**E4350B-03A**

**S E R V I C E N O T E**

**E4350B SOLAR ARRAY SIMULATOR, 0-60 VDC, 0-8 A, 480W. GPIB.**

**The Peak to Peak Ripple & Noise at 20 kHz, when operated as a Solar Array Simulator is Out of specification.**

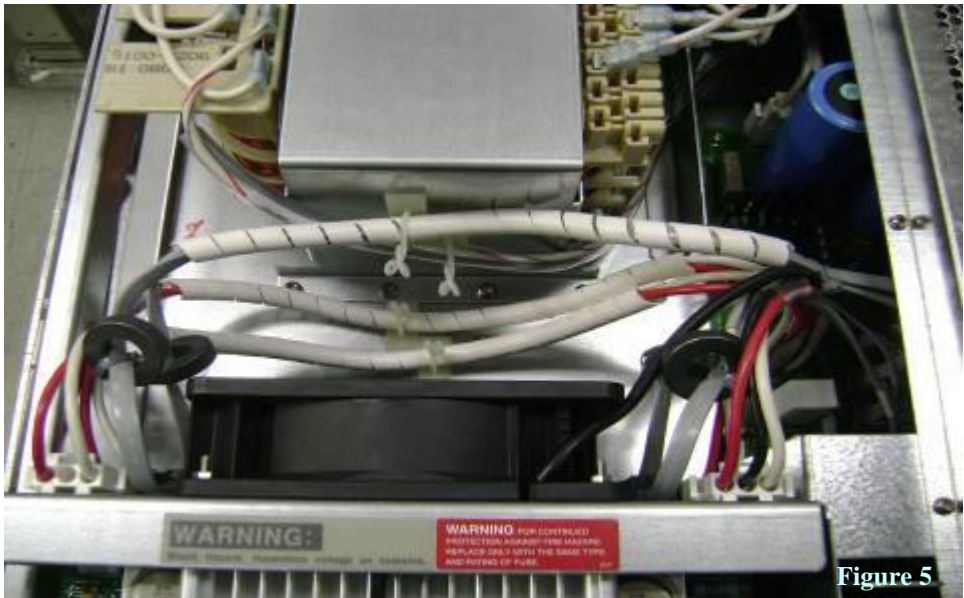
Place 9 inches Spiral Wrap Tubing (P/N 5185-8884) around the cable as shown.

- 1) Place cores (P/N 9170-1497) on 2 short phone cables (06652-80010) and 2 long phone cables (06652-80011)

- 2) Secure the core to the 4 phone cables with a cable tie (P/N1400-3203)
- 3) Wrap a piece of 9 inch Spiral Wrap Tubing (P/N 5185-8884) around phone cables (P/N 06652-80011)

**The following changes are made to all SAS control PCA's**

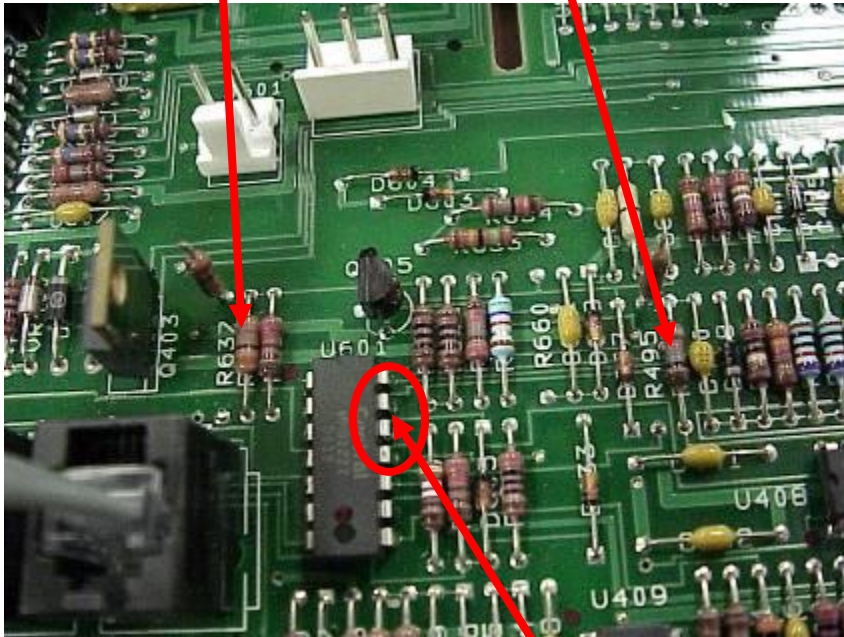
- 1) Delete R637 PN 0757-0417, and R495 PN 0757-0434:

- 2) Add a jumper wire to connect U601 pins 12 & 13 together, on the bottom side of the PCB. Use a 26 AWG wire PN 8150-2408 19.75 mm long and strip 4 mm off each end.

- 3) Change R471 from 100 ohms PN 0757-0401 to 301 ohms PN 0757-0410.
- 4) Add resistors R800 365K PN 0699-8987 and R801 value depends on model as shown below.

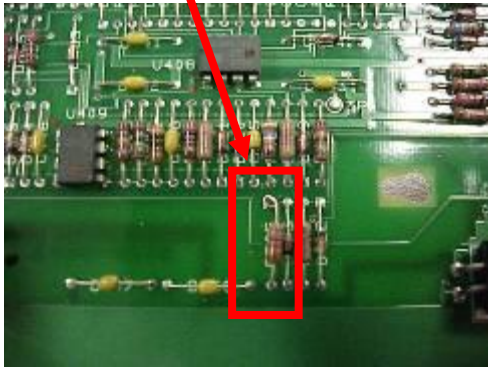
- 5) Bend one end of R800 PN 0699-8987 to a right angle on the other end add a black 22AWG wire PN 8150-3483. The wire should be 174mm long and both ends should be stripped 5mm. Attached the wire with a good mechanical connection.

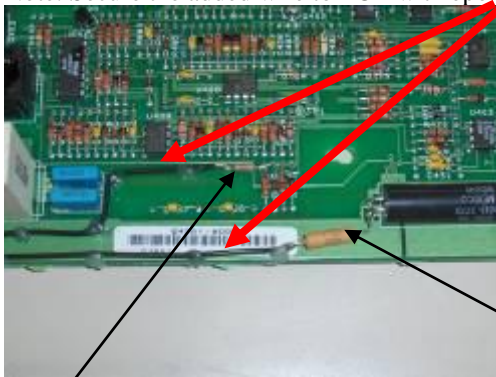
- 6) Desolder R505 and put a loop so R800 can be inserted into the PCB.
  - a. OR Wrap the lead of R800 around the correct side of R505.

Note: Secure the added wire to PCB with epoxy or hot melt glue.

R801 p/n depends on model

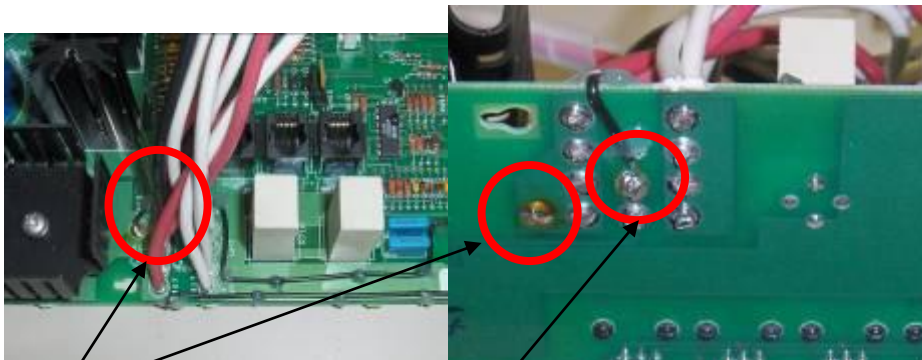
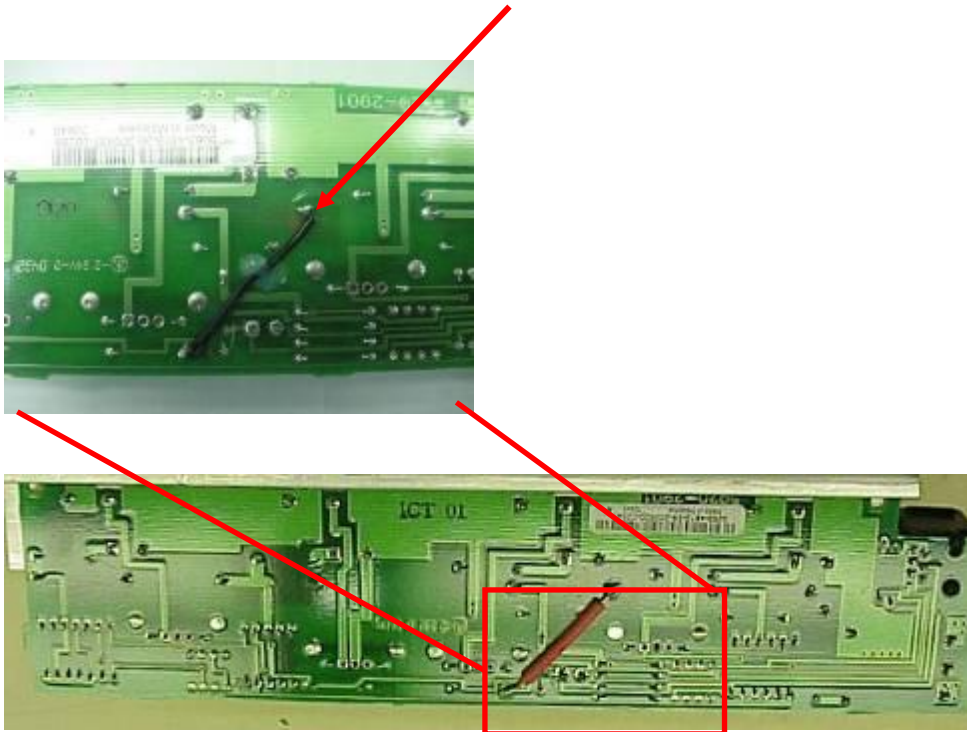
- 7) R801 is to be added with the value as indicated for each model in the below listing.
- 8) R801 will be added from + OUT Inboard to –Rail.

**Note** the value of R801 changes depending on the option. See values below for details:

- a. E4350B J01 PCB PN E4350-60031 R801 34.8K ohm P/N 0698-3420
- b. E4350B J01 PCB PN E4350-60027 R801 22K ohm P/N 0764-0045
- c. E4350B J03 PCB PN E4350-60033 R801 34.8K ohm P/N 0698-3420
- d. E4350B J06 PCB PN E4350-60030 R801 26.1K ohm P/N 0698-4731
- e. E4350B J02 PCB PN E4350-60030 R801 22.1K ohm P/N 0764-0045

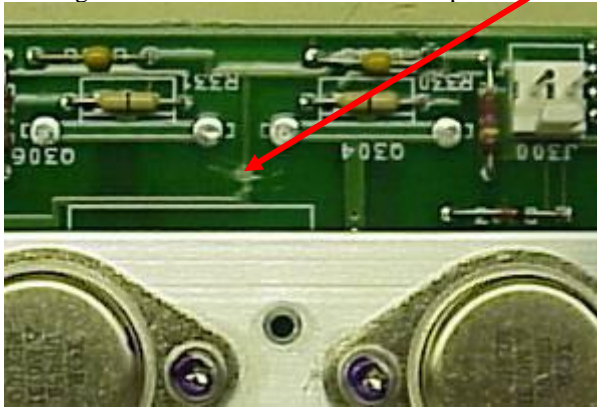
1. Figure below shows right tunnel assemble P/N 5063-4815 PCA ready for rework, for a REV A2 PCB P/N 5020-2901.
2. Remove ground wire from Capacitor C305 to minus side of source resistor R306.

3. Add ground wire 22 AWG by wrapping and soldering wire from minus side of Capacitor C305 to pin one of J300.

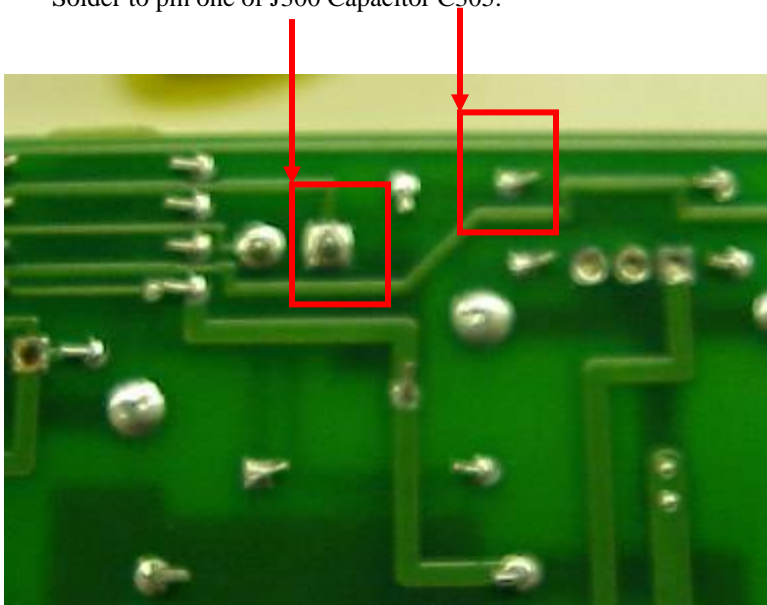
6. Cut ground tract from minus side of Capacitor C305 to minus side of source resistor R306.

8. Add ground wire 22 AWG by wrapping and soldering wire from minus side of Solder to pin one of J300 Capacitor C305.

9. PCA with wire added modification for right tunnel assembly PN 5063-4815 for PCB 5020-2901 REV B completed.
